U.S. NUCLEAR REGULATORY COMMISSION

In the Matter of American Energy Co. LLC

D. Ashley - FW: Audit Q & A (Question Numbers AMP-141, 210, 356)

NRC Information Request Form

Oyster Creek Drywell Vessel Corrosion Rate Trending Program

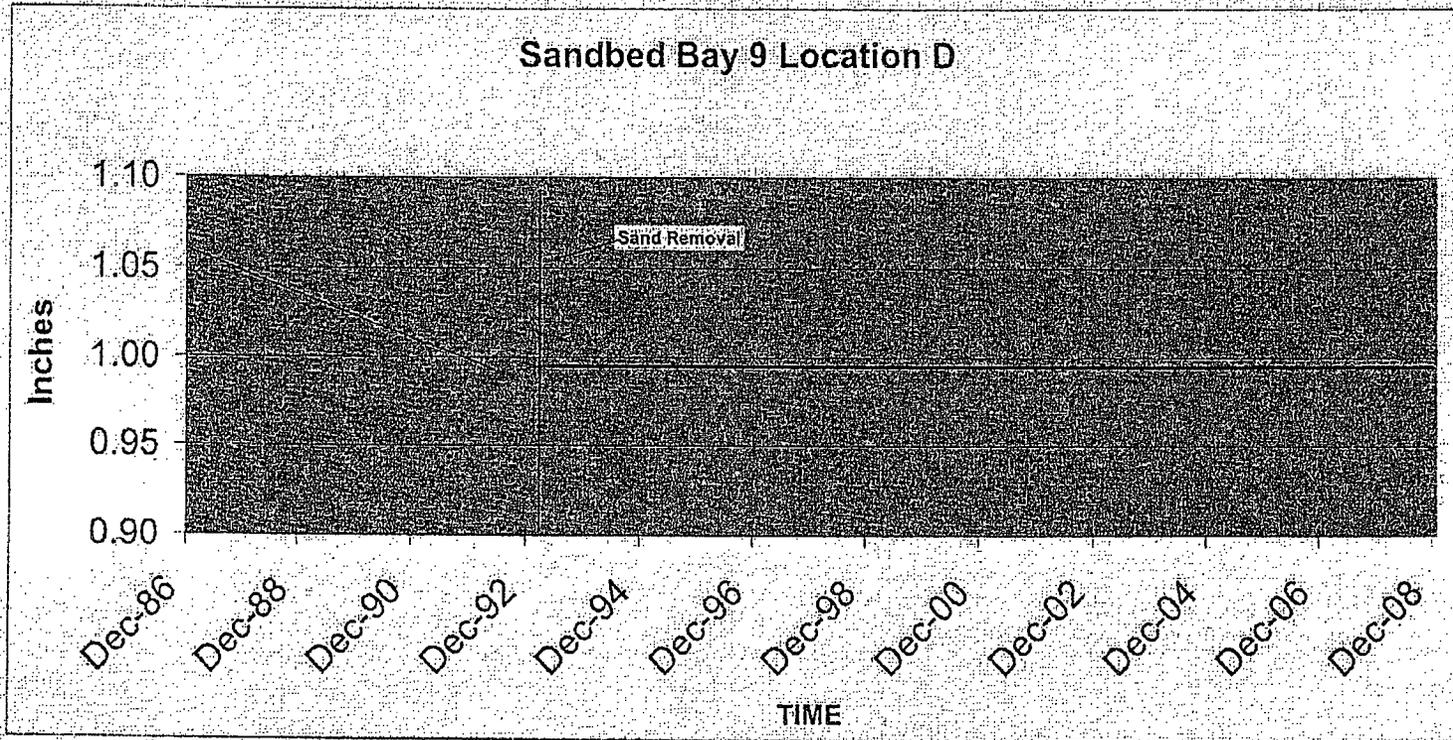
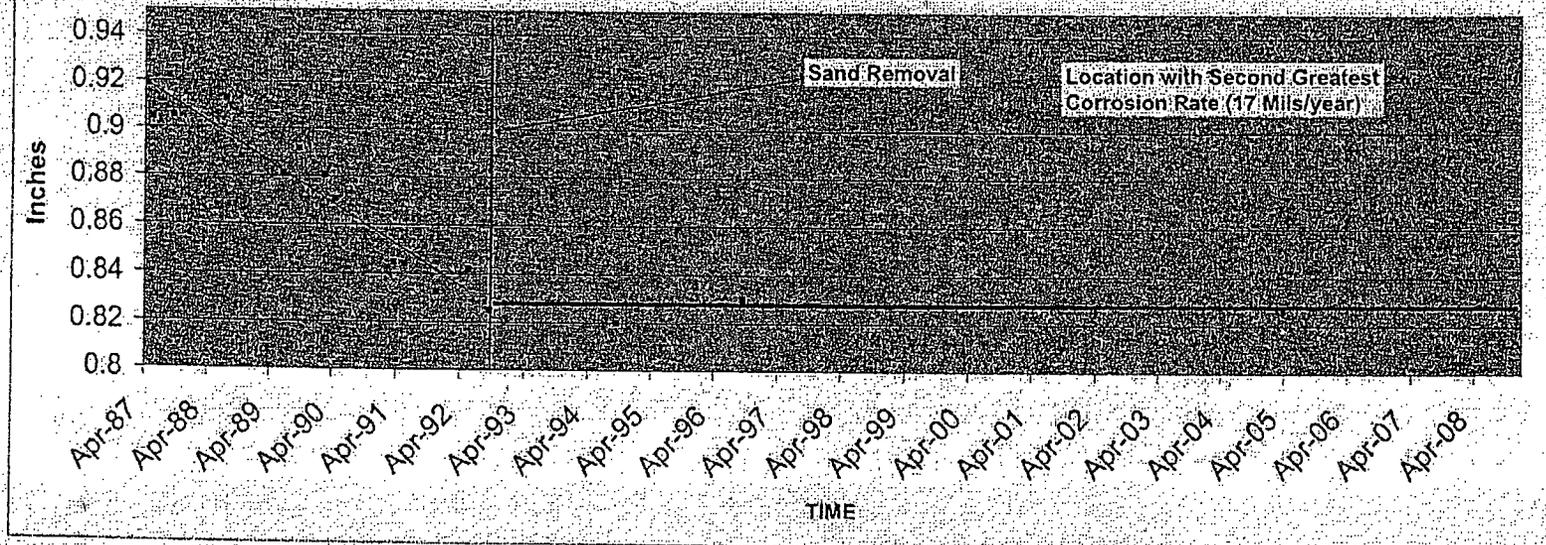
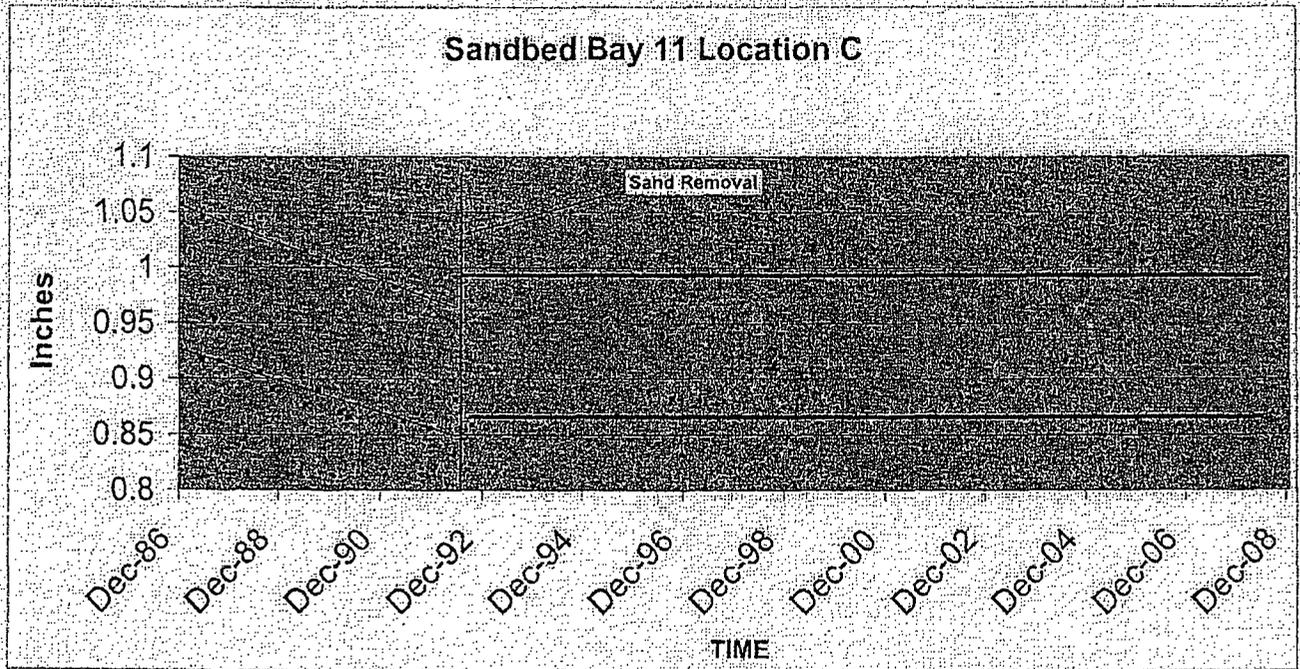
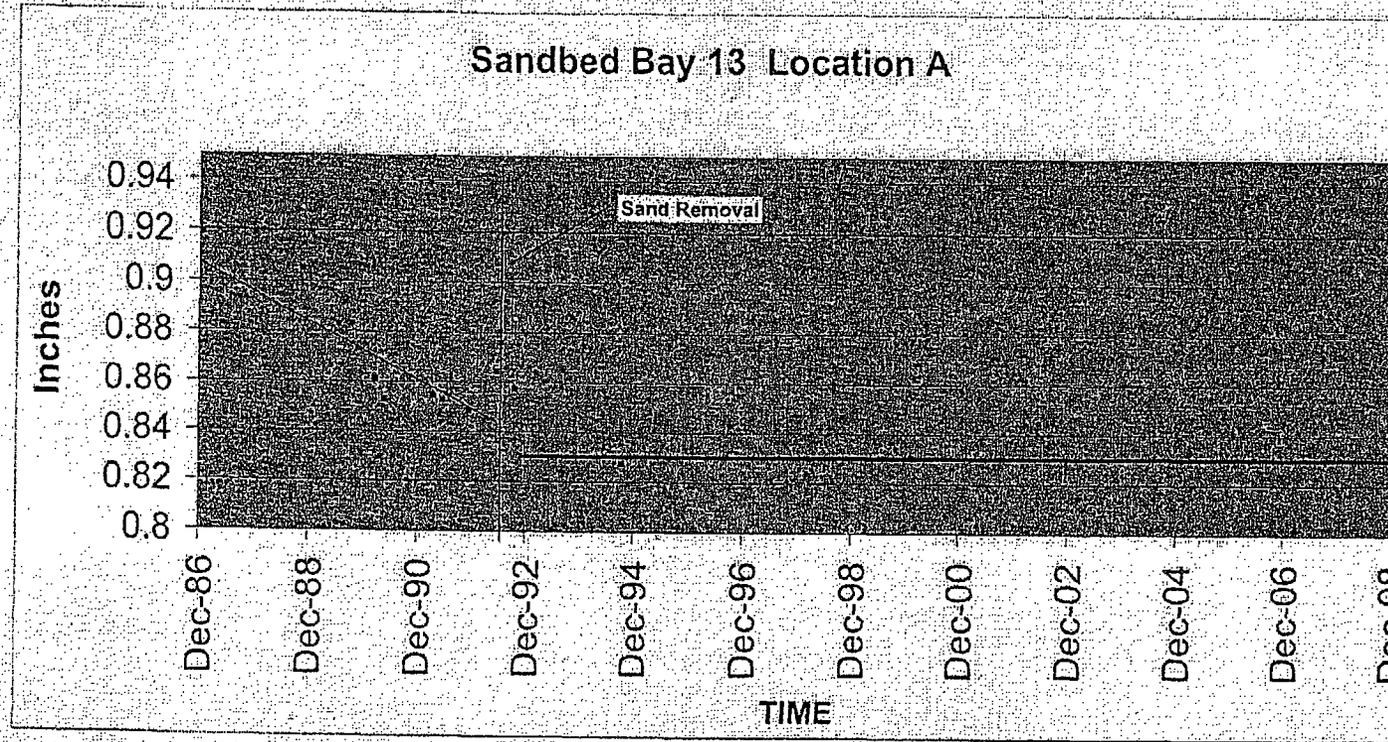
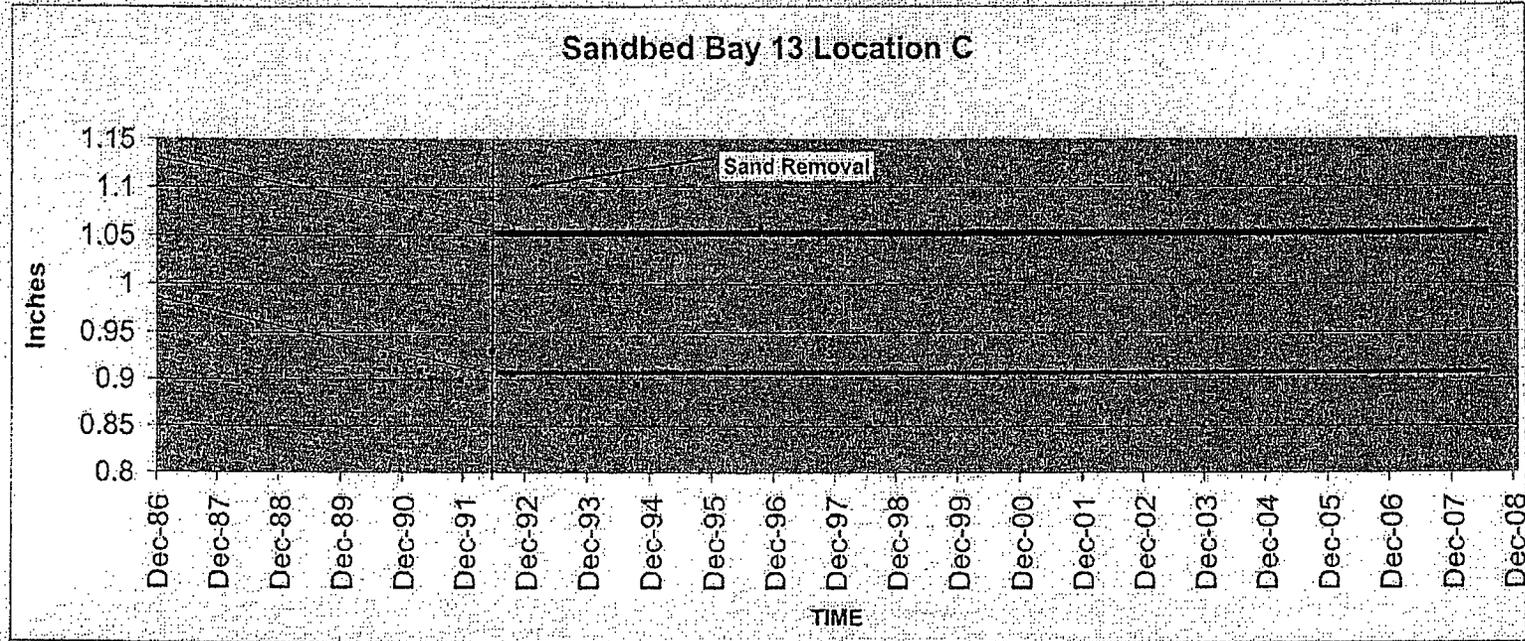
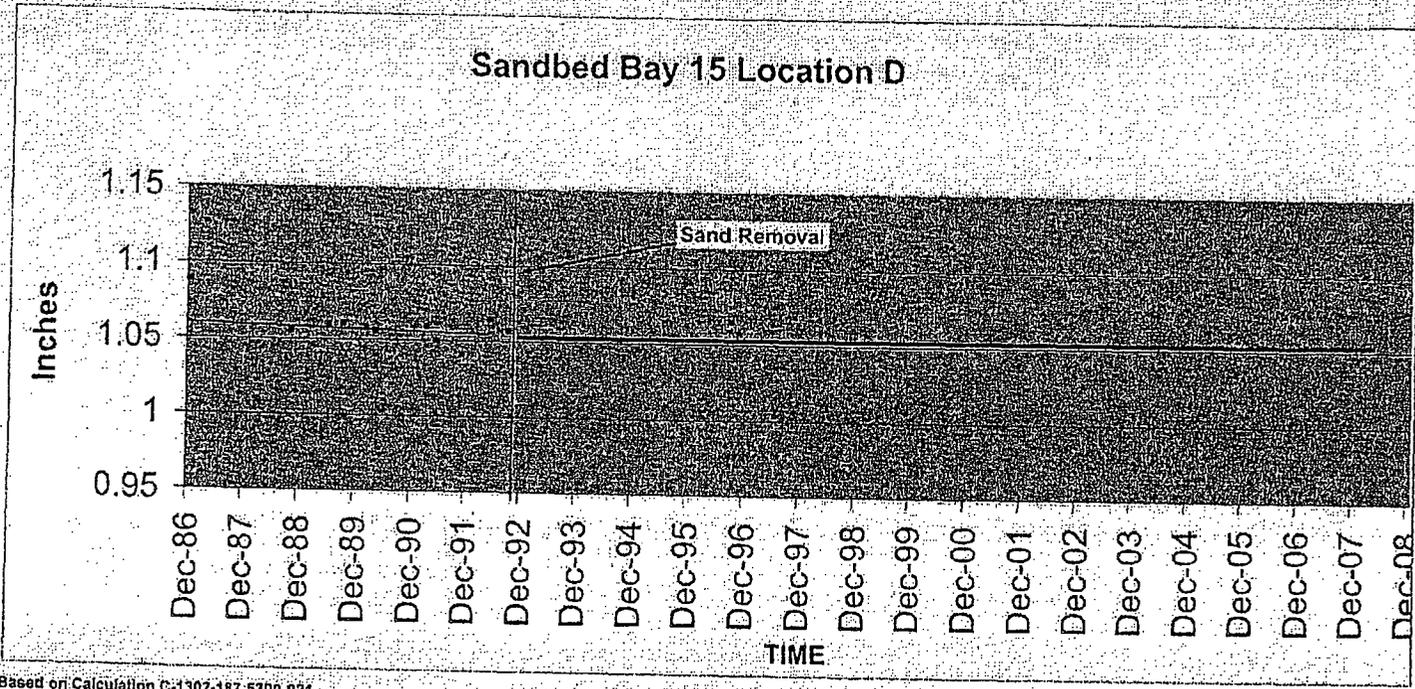
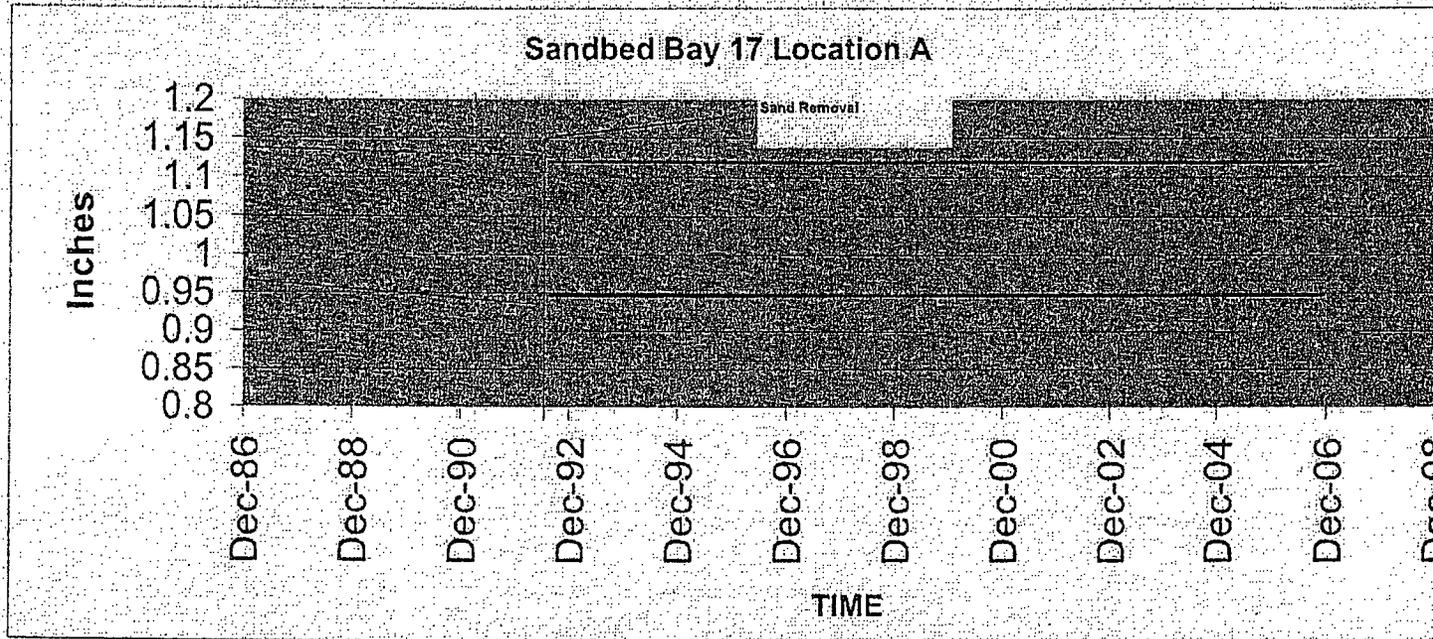
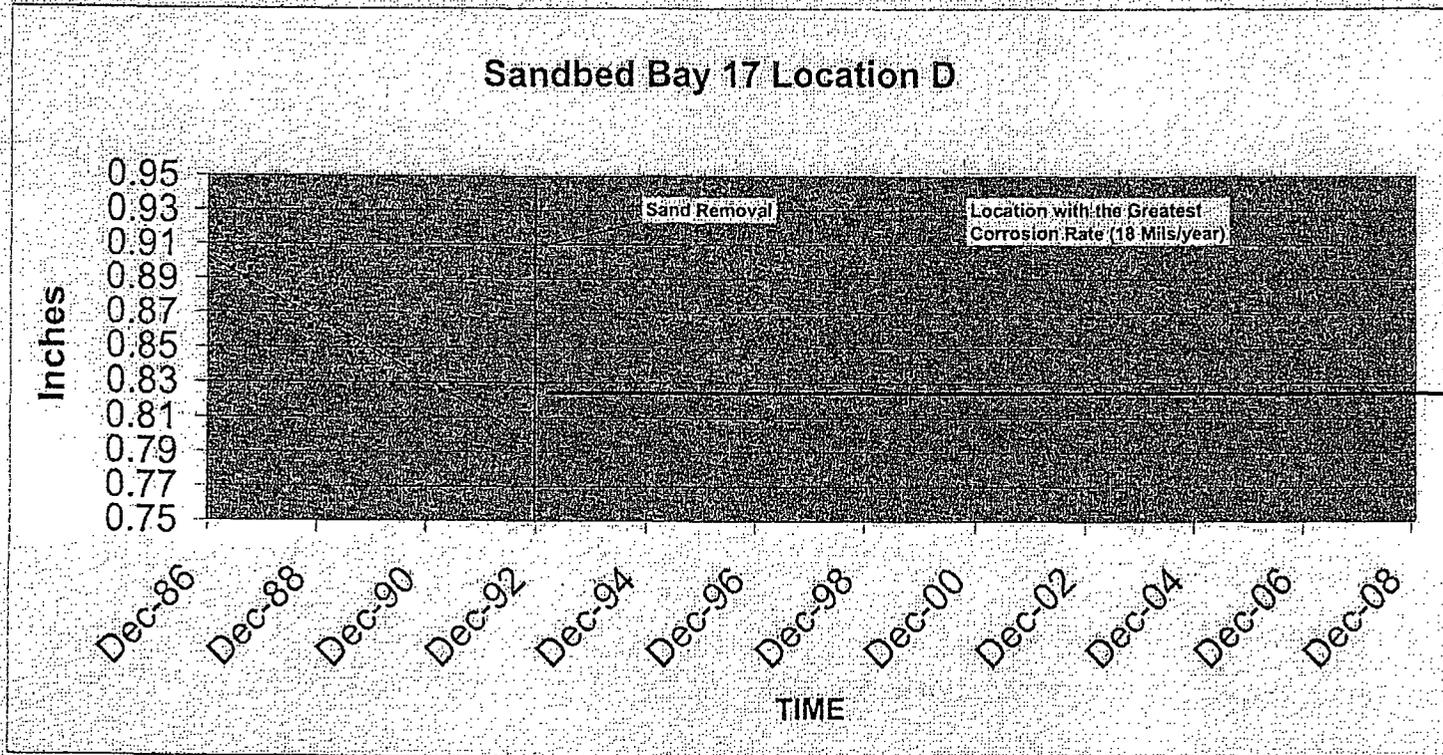
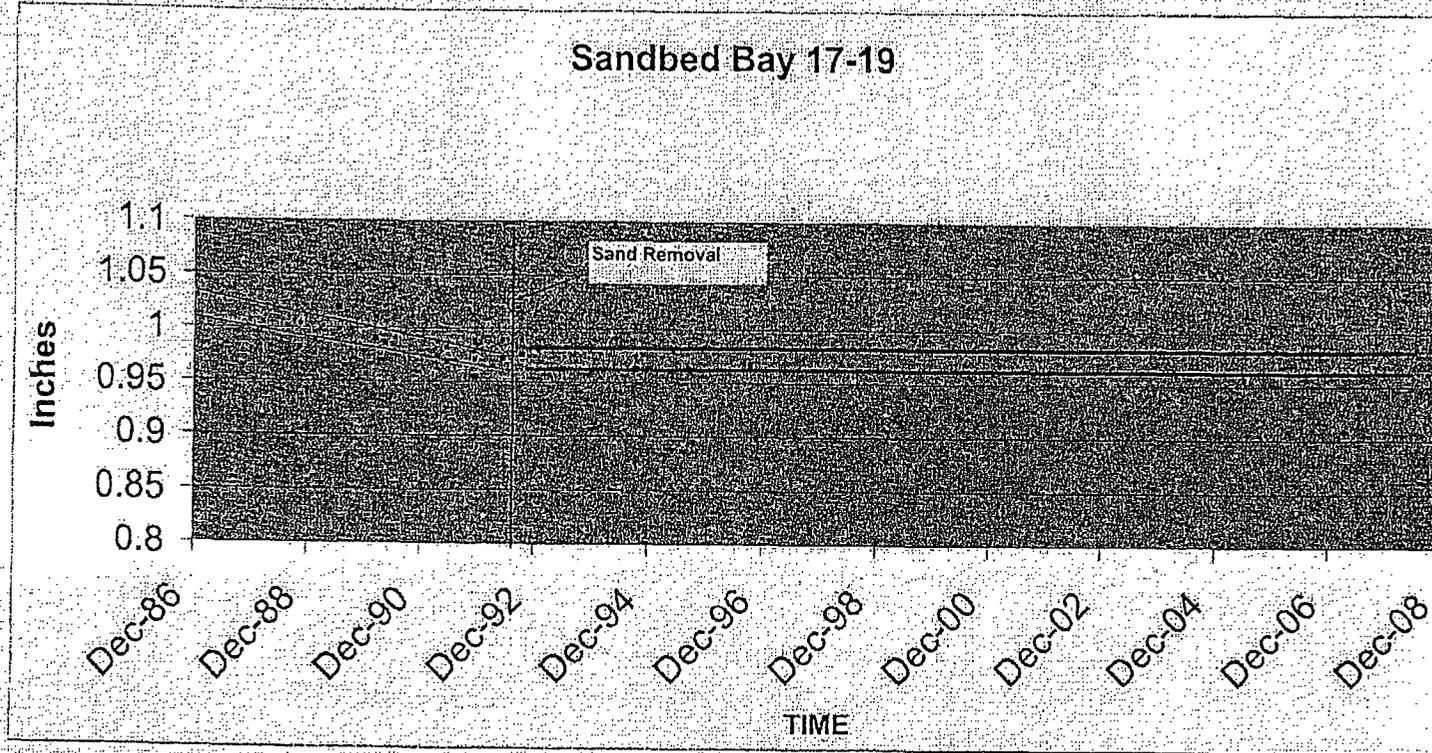
(3) For each grid location, submit a graph of remaining thickness versus time, using the UT readings since the initiation of the program (both prior to and following removal of the sand and application of the external coating).

3. A graph representing the remaining thickness versus time using UT reading since the initiation of the program (both prior to and following removal of the sand and application of the external coating) for location 9D, 11A, 11C, 13A, 13D, 15D, 17A, 17D, 17/19, 19A, 19B, and 19C is included in the attached graph. Other locations (i.e. 1D, 3D, 5D, 7D, 9A, 13C, and 15A) are not included because wall thinning is not significant and the trend line will be essentially a straight line.
